### Zoning and Design Review Board Staff Report

**DATE:** February 11, 2025  
**TO:** Board Members  
**FROM:** Aaron Hecock, Planning & Building Director  
**PREPARED BY:** Kari Svanstrom, Contract Planner  
**APPLICANT:** Casey Hughes  
**OWNER:** Matthew and Amy Sapp  
**ADDRESS:** 2 Tallent Lane (APN 036-041-032)  
**LAND USE CLASSIFICATION:** RS Single Family Residential

Adopt Resolution Number 25-023 conditionally approving a Design Review and Tree Removal Permit application for 2 Tallent Lane and finding the project exempt from the California Environmental Quality Act (CEQA).

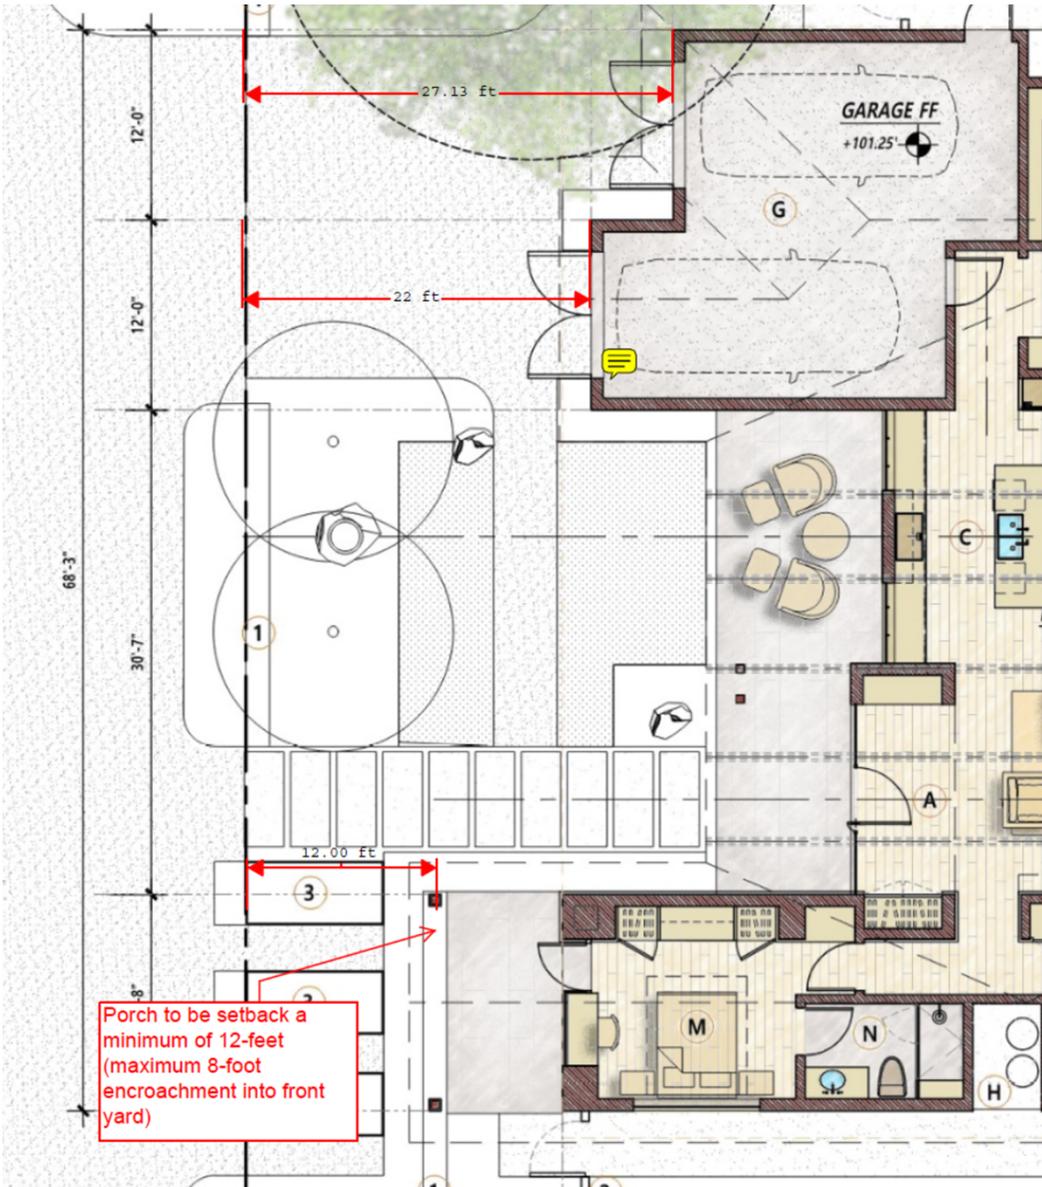
One of the Design Standard for Roof Forms is that the “main roof of the building shall have a minimum pitch of 4 in 12 (4:12).” The project proposes two street-facing gable roof elements with a 5:12 pitch, which exceeds this standard, while the main roof, which is parallel to the street and therefore not visible from the street, is proposed

to be 3:12.

Staff have discussed this roof pitch Design Standard with the applicant, and they are able to adjust the pitch of the main roof form to be 4:12 if required by adjusting internal plate heights. Staff is requesting the ZDRB review this component to determine whether to (1) condition approval of the project on adjusting the main roof pitch to 4:12 or (2) to waive this Design Standard, as allowed through the Design Review process by YMC 17.40.020 ("The following are design standards, which all residential projects are required to conform with unless waived by design review approval as regulated by Chapter 17.188 of this title."). Staff believe that a waiver of the 4:12 pitch for the main roof is supportable given the low visibility of this roof from the street and the higher 5:12 pitch of the two front gabled roofs. If the ZDRB feels the 4:12 pitch is needed, it should add the following as a Condition of Approval: "The main roof pitch shall be adjusted to be a 4:12 pitch."

(1) Add a condition of approval requiring the main roof be designed to have a 4:12 pitch or (2) waive this design standard through design review approval. Staff recommends that the ZDRB waive the 4:12 roof pitch design standard given the higher sloped gable roof elements facing the street and low visibility of the main roof from the street.

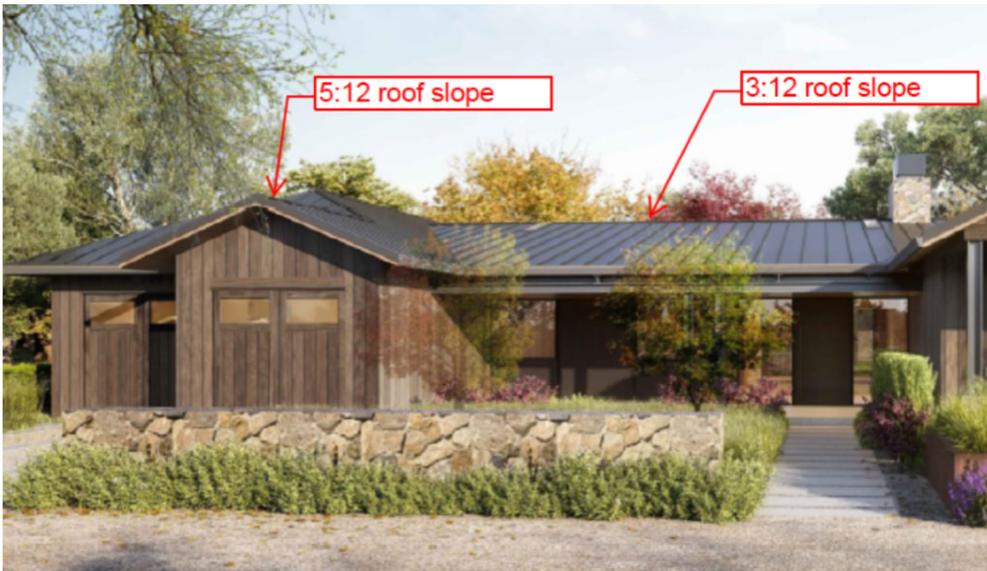
The Design Guidelines encourage garages “to be located in the rear half of the lot,” and the Design Standards related to garages discourage multi-vehicle garages located in the front of lots unless the following condition can be met “Multi-car garages are permitted if located on the rear half of the lot or screened from view from adjacent street frontages by building placement, landscaping, and/or fencing in compliance with Chapter 17.136.”

As noted above, while the current detached garage is located at the rear of the lot, the vehicle access is through an adjoining property, without any recorded easement for this access. The project proposes to eliminate this issue and place a two-car garage at the front of the lot. While the initial design included a more prominent double garage, after discussions with staff in relation to the Design Guidelines and Standards, the applicant has revised the project to address the above requirement for screening multi-vehicle garages at the front of the lot.

As required by the Design Standards, the garage is set back 10-feet further than the home from the street. As discussed above, the south porch, as conditioned, will project 8-feet into the front yard (an allowed encroachment) and therefore be set back 12-feet from the front property line, while the south bay of the garage is setback 22-feet from the property line.

The second garage bay is split from the first to avoid a double garage door, and to set back the second garage

an additional 5-feet 2-inches (27'2" setback), so that it is tucked in behind the canopy of the valley oak to the north. The two garage doors are proposed as carriage-style garage doors in the same vertical grain wood material as the siding for the home to minimize the prominence of the garage bays. Glazing on the garage doors includes two windows at the top of the door.

The project also incorporates a three-foot solid stone fence with plantings in front along the front of the lot to further screen the garage bays. With the separation of the garage bays into two volumes and setback of the northern bay so that it is screened by trees and shrubs from the north and the building to the south, staff believes the design can be found to meet the Design Standard in that the garage is screened from the adjacent frontage by the building's placement, and the site fence and landscaping.

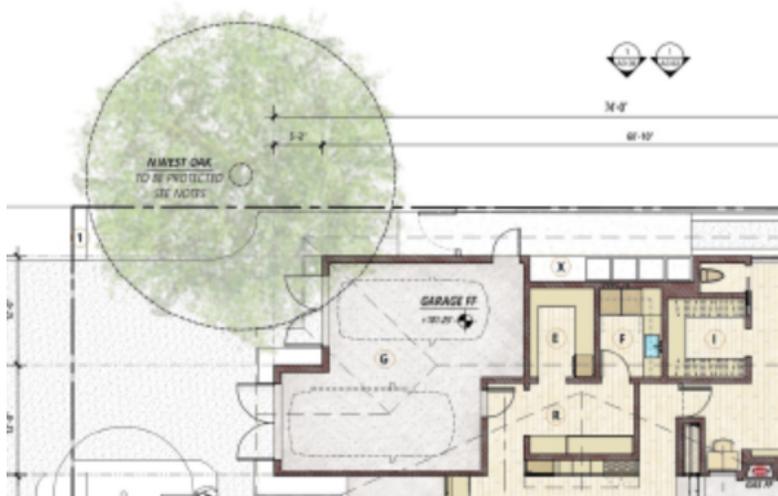
There are two heritage trees just off-site of this property, with significant canopy areas overhanging the site, a 32-inch valley oak (aka white oak) in the front yard of 1951 Yountville Cross Road, the property to the north, and a 30-inch coast live oak on 6 Tallent Lane with an overhand at the southeast portion of the site.

The front/north valley oak just north of the driveway has had some adverse trimming from PG&E. However, the Town Arborist, Tony Walcott, notes that the tree is otherwise in good condition. The second tree is the 30-inch coast live oak on the 6 Tallent Lane property and directly south of the southeast corner of the site. This tree has been deemed to be in excellent condition by both the Project Arborist and Town Arborist.

Staff has worked with the applicant throughout their submittal process regarding the potential impacts on these two heritage trees, and the applicants have revised the original submittal to remove any significant grading in the proximity of the rear coast live oak tree. The proposal also removes an existing deck adjacent to the existing garage which currently encroaches into the dripline.

On the north side of the site, underground utilities originally proposed in the north setback have been relocated to the south side of the site to avoid significant trenching within the critical root zone (CRZ) of the 32-inch valley oak to the north. Additionally, the driveway construction has been modified from a standard concrete driveway to a gravel driveway over a geogrid material. This is a strong mesh material that is laid down to form the frame of the driveway and then filled with gravel. The northern garage bay is also set back further than the southern bay, partially to respond to the garage Design Standards discussed above, but also to minimize the home's footprint within the dripline of the tree.

The project's Landscape Architect has proposed a number of measures that will minimize disturbance to the valley oak north of the driveway (Attachment 6 – Landscape Letter). These include eliminating any irrigation (irrigation at inappropriate times can make an oak susceptible to sudden oak disease); avoiding compaction within the critical root zone; and 'bridging' over major tree roots that may be discovered in the excavation of the driveway to avoid cutting major roots and to protect them from compaction.

The Town Arborist has reviewed these recommendations and finds them generally acceptable. His one additional recommendation is to prohibit all trenching within the chain link fence that will be required for tree protection during construction around the valley oak. Should work within this protected zone become necessary, it must be conducted under the direct supervision of either a Registered Certified Arborist Consultant or a Board-Certified Master Arborist, with all digging performed by hand. Staff have included this in the Conditions of Approval. A Tree Protection Plan outlining the location of tree protection fencing and these and other required measures will be required at the time of building permit for review and approval by the Town Arborist prior to the start of any work at the site. Additionally, the town's Duty of Care for protected trees and additional duty of care for heritage trees found in YMC § 17.128.090 and 17.128.100 will be required for the project.
